Town of Surfside

ITB 2024-01

Abbott Avenue Stormwater Improvements Project

Addendum No. 4

SHEET NUMBER **E-300**

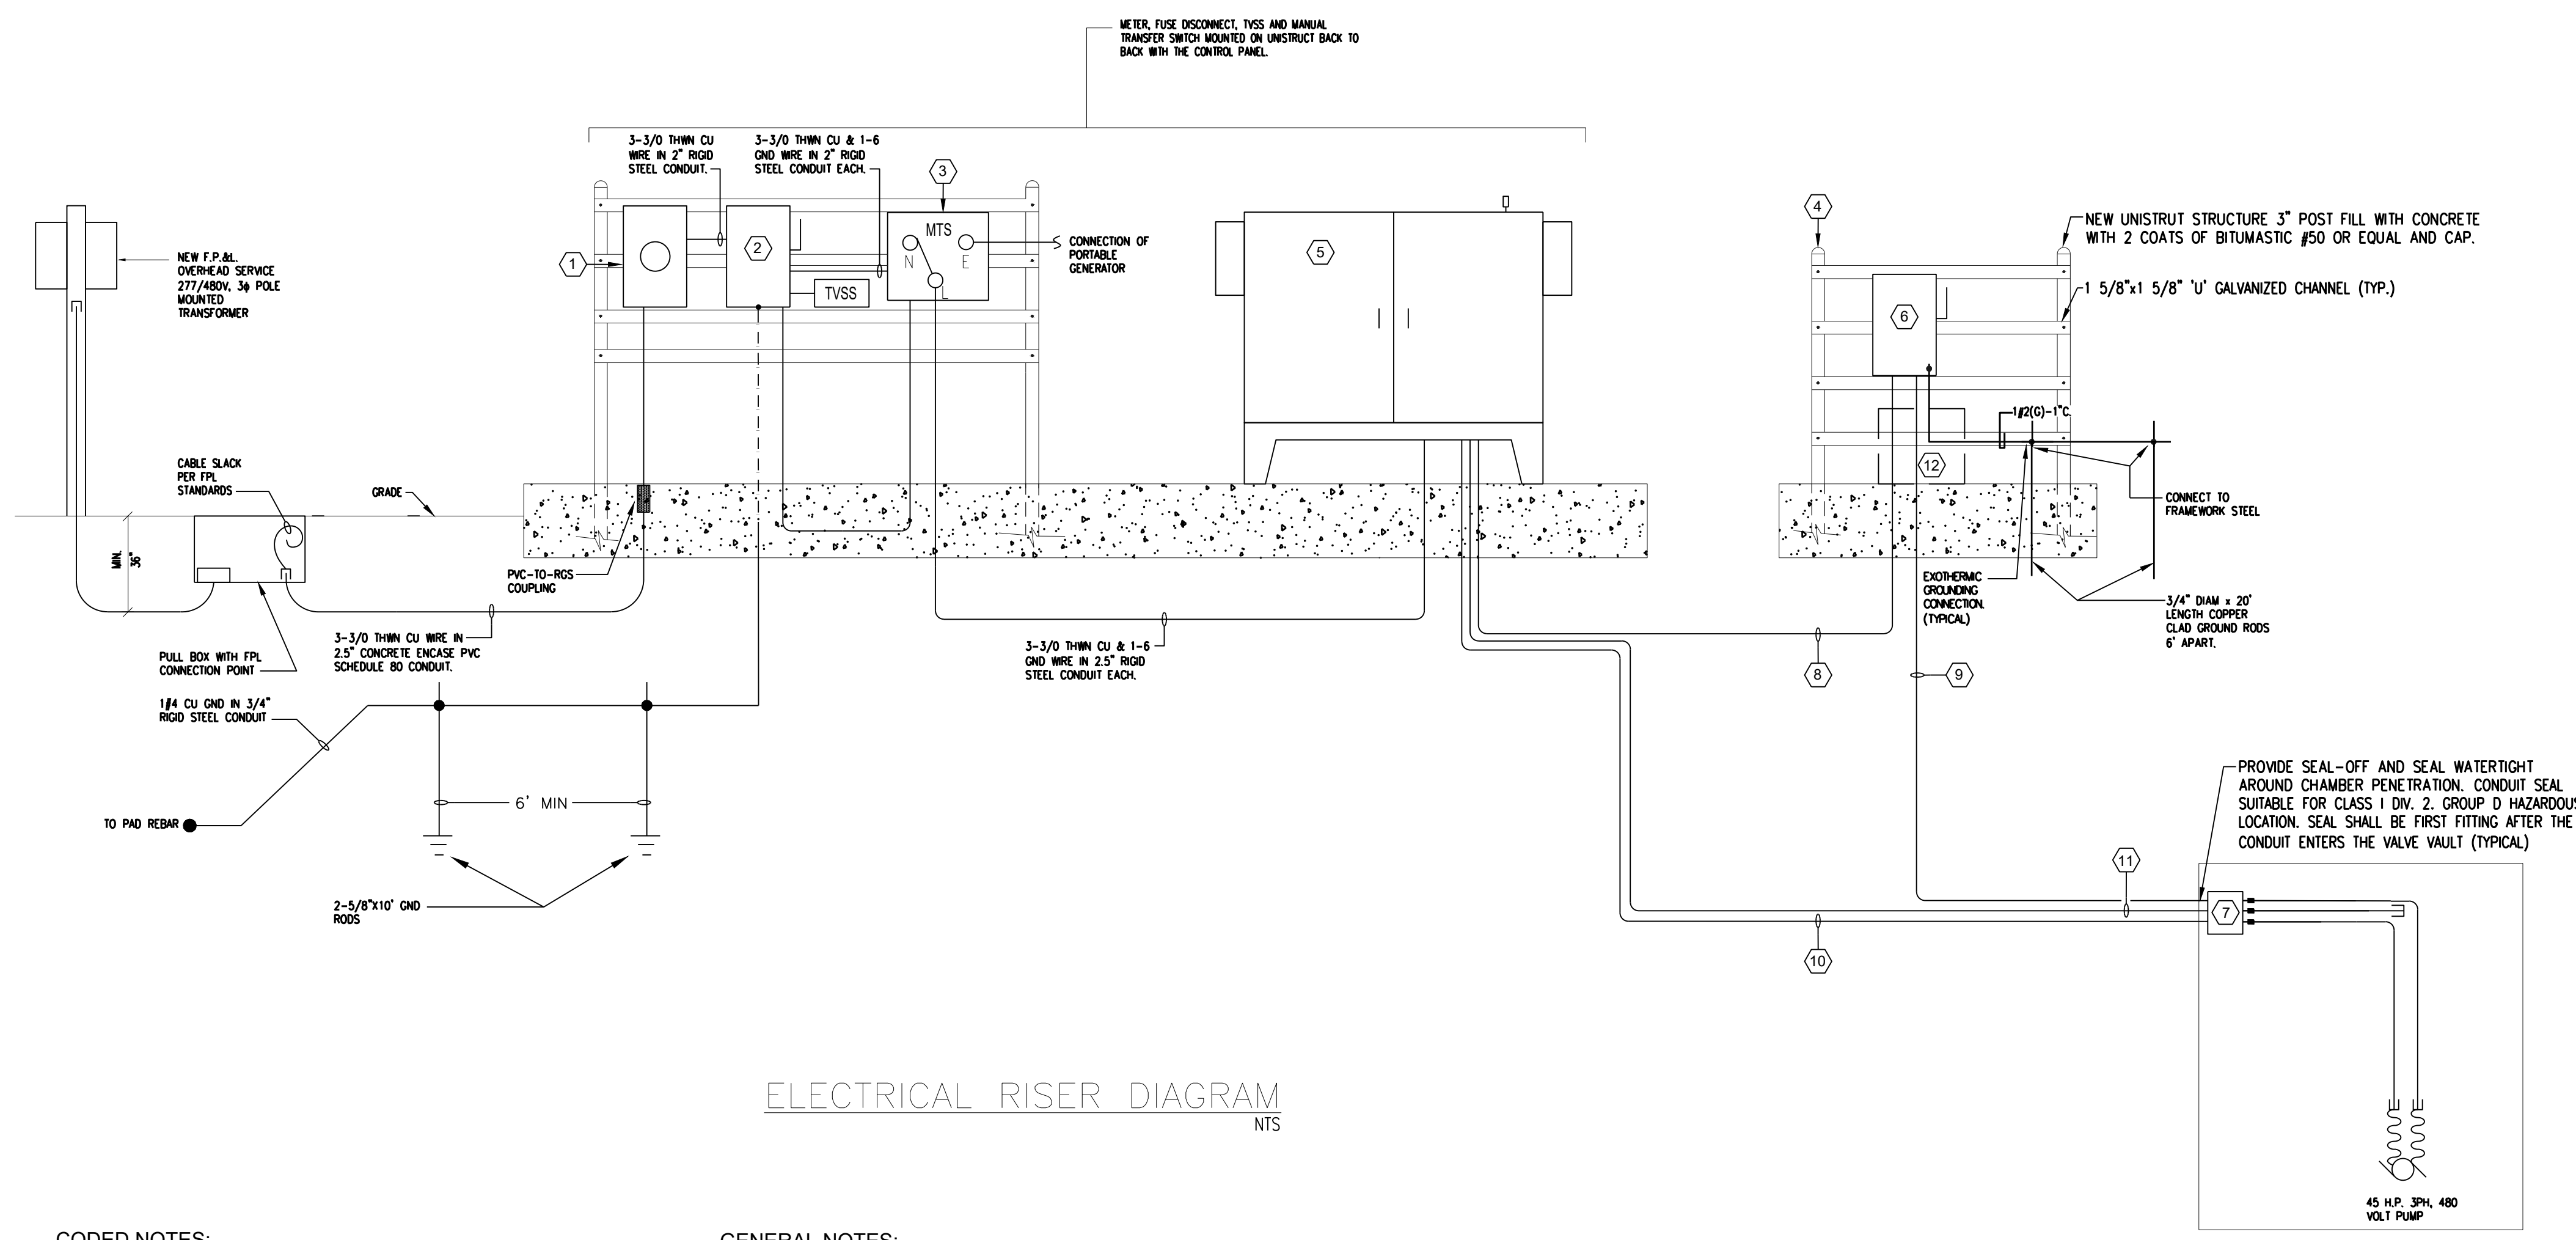
- 3. **Question/Comment Received:**. addendum #3. Sheets E-300 & E-400 still show (1) 140HP & (1) 35HP pumps, but the new add 3 pumps are now proposed at 45hp, one for each pump

station. Please confirm.

- 8. Question/Comment Received: Control Panel Sheets E-300 & E-400 still show (1) 140HP & (1) 35HP pumps, will there be updated drawings supplied? Since the pump stations are now designed for a 1 pump operation, are the control panels to be set up for simplex operation or duplex operation with the same newly specified pump 45HP? Possibly for future installation of secondary pump. Need clarification.**

Town Response: See Amended Electrical Plan Sheets issued with this addendum.

Town Response: See Amended Electrical Plan Sheets issued with this addendum. Intent is single pump, simplex operation at each station.

SHEET NUMBER E-301
PROJECT NUMBER 11494.01

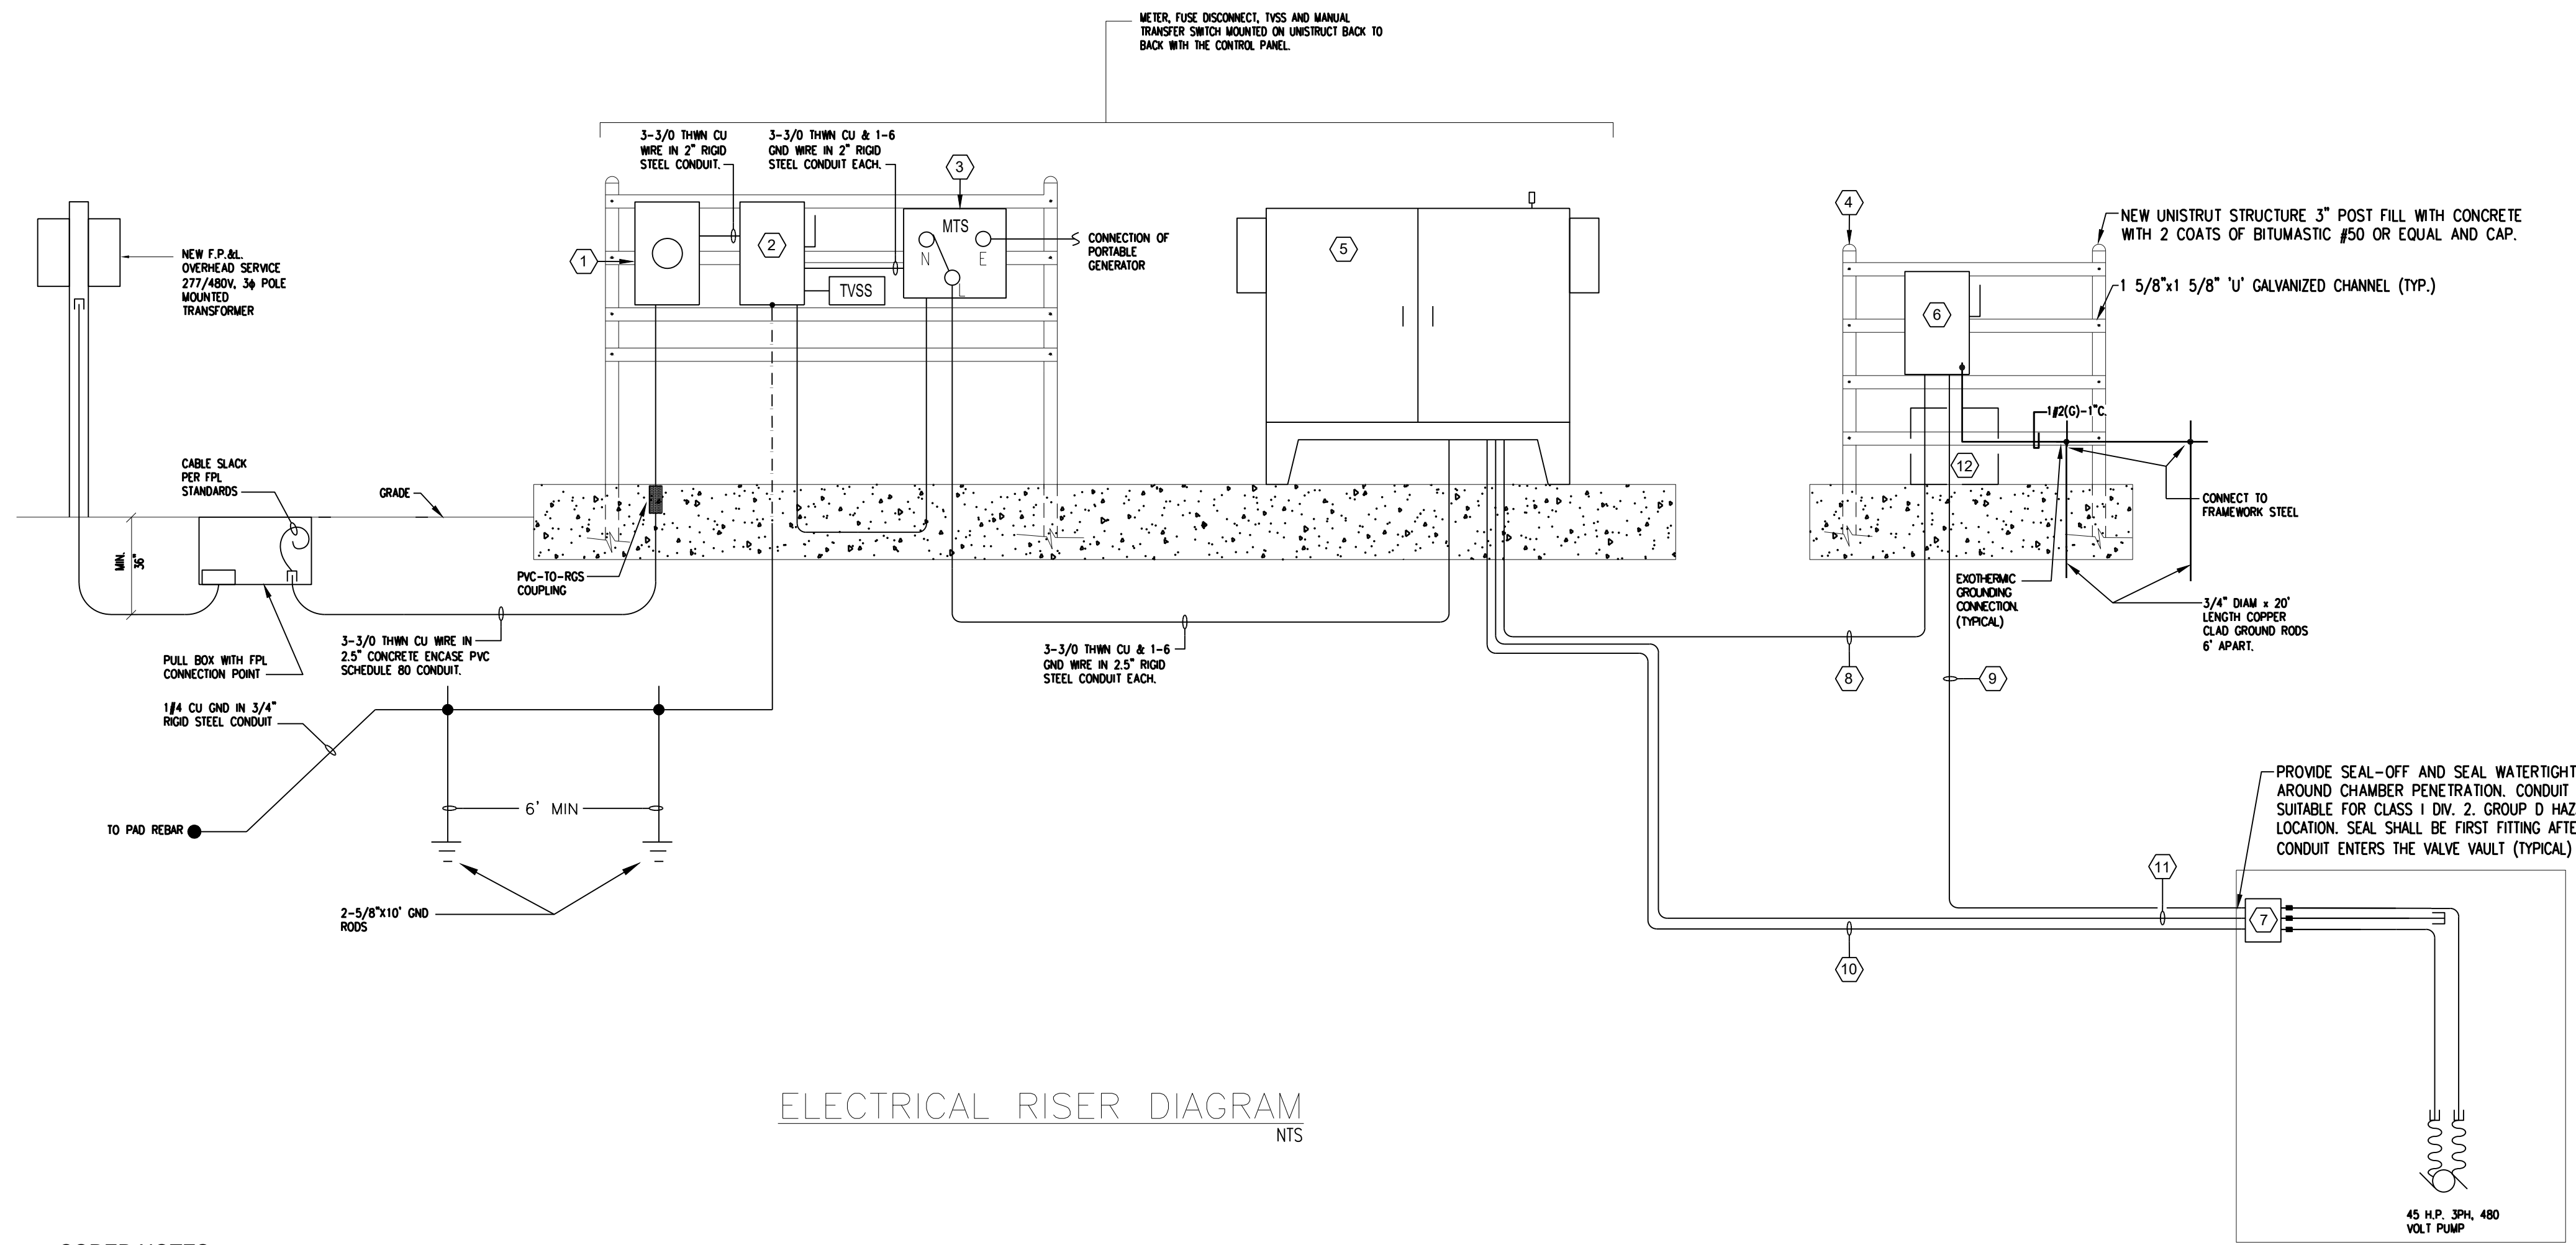
- 1. The Electrical Plan revisions reflect the change to a single pump, simplex operation at each of the two Pump Stations.
- 2. The Power services were changed to 200 Amp Services.

1- 45 H.P. PUMP	77 AMPS.
ENCLOSURES' AIR CONDITIONERS	14 AMPS
MISCELLANEOUS BASE LOAD	30 AMPS.
25% OF LARGEST MOTOR	19.25 AMPS.
TOTAL	140.25 AMPS.
PROVIDE SERVICE SIZE: 200 AMP, 277/480 VOLT, 3φ, 4W
